Access Compliance Report

Public Rights-of-Way

Intersection ID: 17196	Main Street: IDLEWILD_RD	Cross Street: CONFERENCE_DR	Location: NE
ADA ID: 38204874BA9C	Ramp Type: Perp	Initial Pass/Fail: Fail	Overall Compliance: No
Severity Score: 12.5			
Codes/Mitigation Info/Possible Solution		Field Measurements/Component Compliance

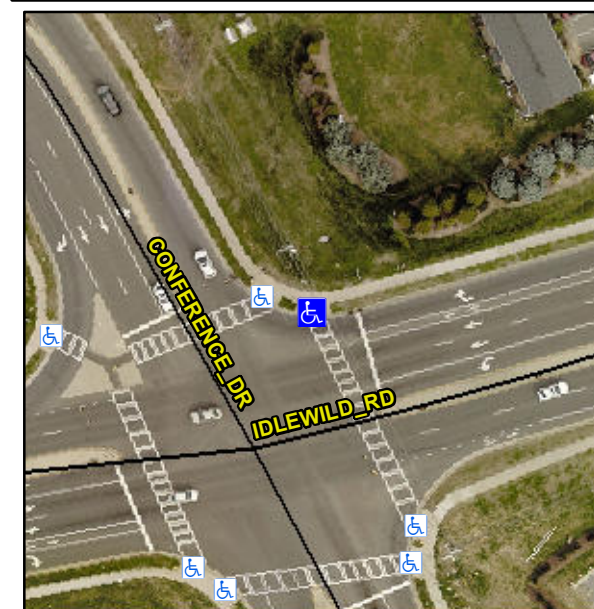
Compliance	Description	Data	Compliance	Description	Data
N/A	Ramp Length (in)	68.0	No	Ramp Slope (%)	8.8
Yes	Ramp Width (in)	48.0	Yes	Ramp XSlope (%)	1.7
N/A	Flare Type LT	N/A	N/A	Flare Type RT	N/A
N/A	Flare Slope LT (%)	N/A	N/A	Flare Slope RT (%)	N/A
N/A	Flare Traversable LT?	N/A	N/A	Flare Traversable RT?	N/A
N/A	Landing Length (in)	N/A	N/A	DWS Provided?	N/A
N/A	Landing Width (in)	N/A	N/A	DWS Contrast?	N/A
N/A	Landing Slope (%)	N/A	N/A	DWS Length (in)	N/A
N/A	Landing X Slope (%)	N/A	N/A	DWS Full Width?	N/A
N/A	Landing Curb? (Y/N)	N/A	N/A	DWS Offset (in)	N/A
N/A	Shared Landing?	N/A			
N/A	Gutter Ponding?	N/A	N/A	Gutter Slope (%)	N/A
N/A	Gutter Lip Ht (in)	N/A	N/A	Gutter X Slope (%)	N/A
N/A	Painted X Walk1?	Yes	N/A	Painted X Walk2?	N/A
	X Walk 1 Direction	To SE		X Walk 2 Direction	N/A
N/A	X Walk 1 Width (in)	94.0	N/A	X Walk 2 Width (in)	N/A
	X Walk 1 Slope (%)	1.3		X Walk 2 Slope (%)	N/A
	X Walk 1 X Slope (%)	1.7		X Walk 2 X Slope (%)	N/A

Remove & Replace Entire Ramp.

R304.2.2
